HISTORIC DISTRICT COMMISSION

CERTIFICATE OF APPROPRIATENESS

Application Number: HDC2026-00002

Project Address: 2310 Edison St

All Wood Double Hung - W/ Historic Sill Nose

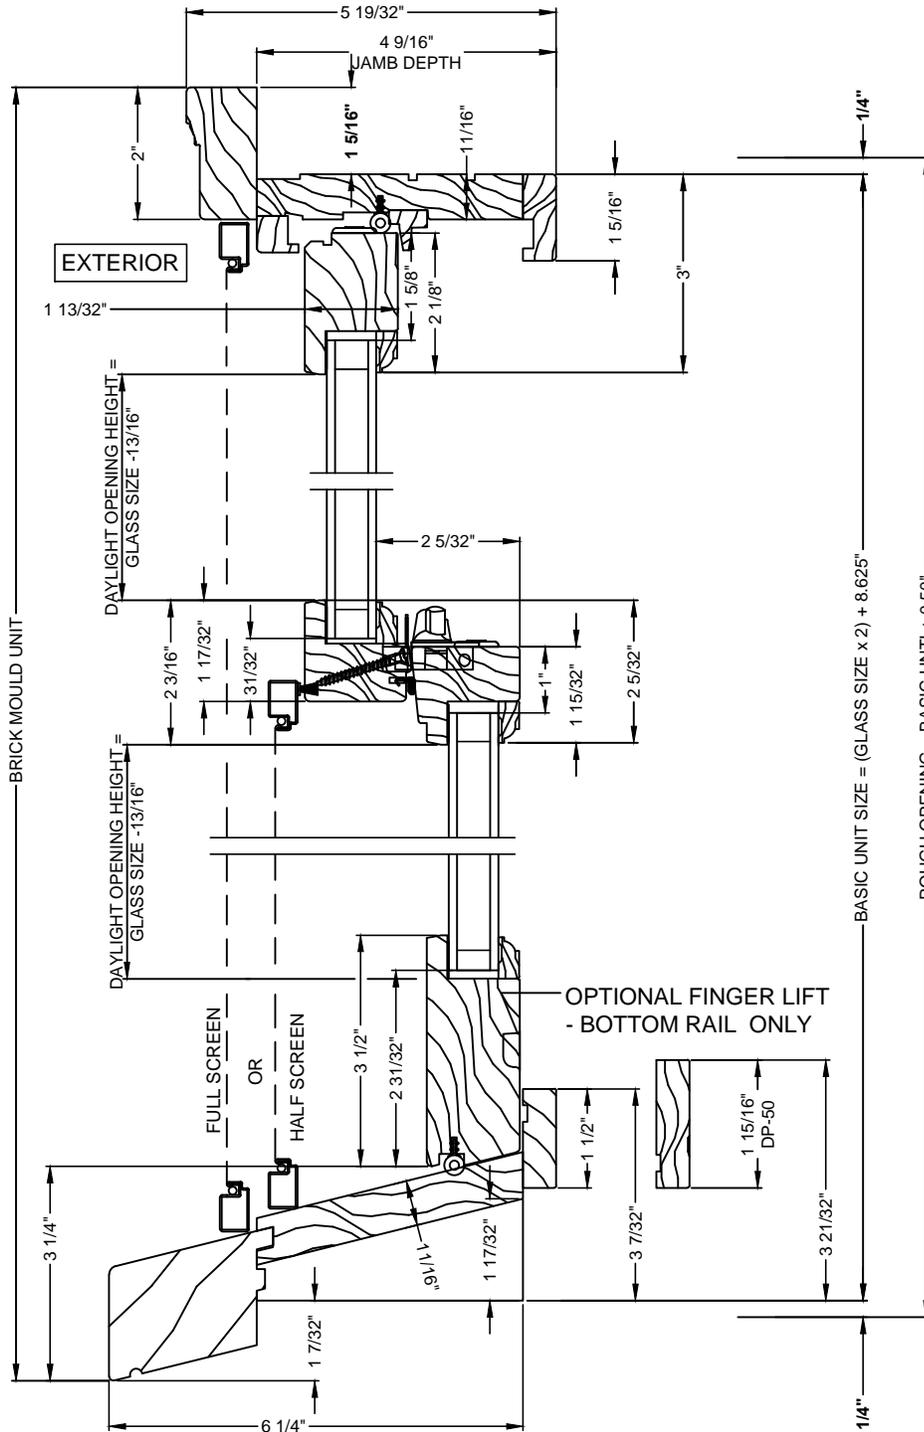
Thank you for the additional information. There is still a question about the 5-3/4" combined height. I am going to research other manufacturers for sections for their solid wood window lines. It is possible that my earlier comparison review may have included sections for aluminum-clad wood windows (they ranged between 4-1/2" and 5" combined height for sill/bottom rail), and not solid wood windows as proposed by the current application.

The submitted section shows a 3-1/2" bottom rail on top of a 3-1/4" sill, creating a bottom component that is almost 7" high. That is very tall and quite different than the historic window (or even the existing vinyl windows). Is the "historic sill nose" optional, or is there a window line within the selected manufacturer that offers a narrower, gently sloping sill, so the overall height of the sill is reduced?

This property's remaining windows were previously approved by the Historic District Commission using Lincoln true wood windows, and as shown in the attached file, the approved Lincoln window proportions fall within the same range as the proposed Sierra Pacific true wood windows. The original contractor on the project, who was listed on the Historic District Commission's approved contractor list, was unable to complete the approved scope, and the originally approved true wood windows were therefore never installed. Because of this, the homeowners did not move forward with aluminum-clad windows and continued to pursue a true exterior wood window solution. While our company most often proposes aluminum-clad wood windows, all of our completed Historic District projects to date have utilized aluminum-clad exterior systems. For that reason, we are unfortunately unable to provide reference addresses featuring completed true exterior wood window installations at this time.

Manufacturer	Combined Rail Stack (Top + Bottom)
Marvin Ultimate Wood DH	5 21/32" (\approx 5.66")
TrimLine Historic Wood DH	5 3/4" (5.75")
Sierra Pacific Historic	~5 5/8" – 5 3/4"
Lincoln Quantum Wood DH	~5 1/2" – 5 3/4"

Here is a link showing the section drawing, in the drawings there is an option for the historic sill nose but we can go without and that gets us to 5-1/2" overall between the sill and bottom sash rail.

Double Hung

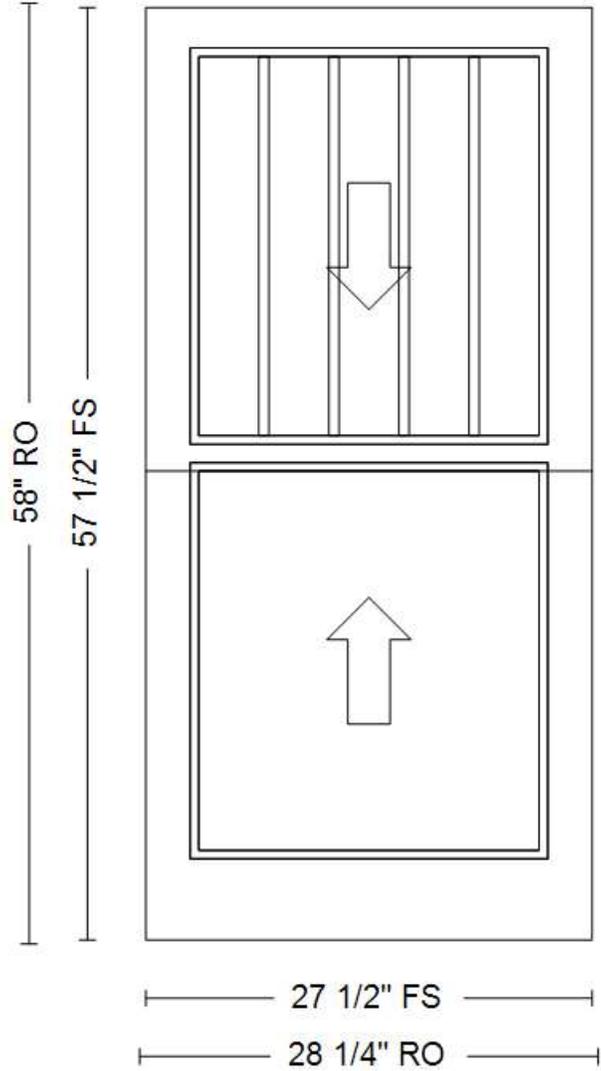
The HDC application, page 2-section 4, states: "Keep all existing brickmould, will NOT be covered with aluminum." However, the window order states an exterior casing set, with a 2" brickmould and sill nose has been specified.

I see the screen frame color selected is "White 001". This appears to be a contemporary bright white and is a color staff doesn't have authority to approve.

Please also confirm the "Low-E Argon" glass and its level of transparency.

As for the brickmould, when we order the windows, the brickmould will come with the units but we do not need to install this section and will leave all existing historic brickmould in place if it exists once we remove the aluminum flashing. If there is no brickmould there, we can install brickmould.

For the frame color, the units will be primed white and must be painted after installation by the homeowner or a 3rd party contractor, as we do not offer painting services. At that time, the units will be painted to match the existing units and the HDC will have the opportunity to approve the final color option that the homeowner matches.

The Low-E argon glass is cardinal 180 standard, which has a visual transmittance of 80%.
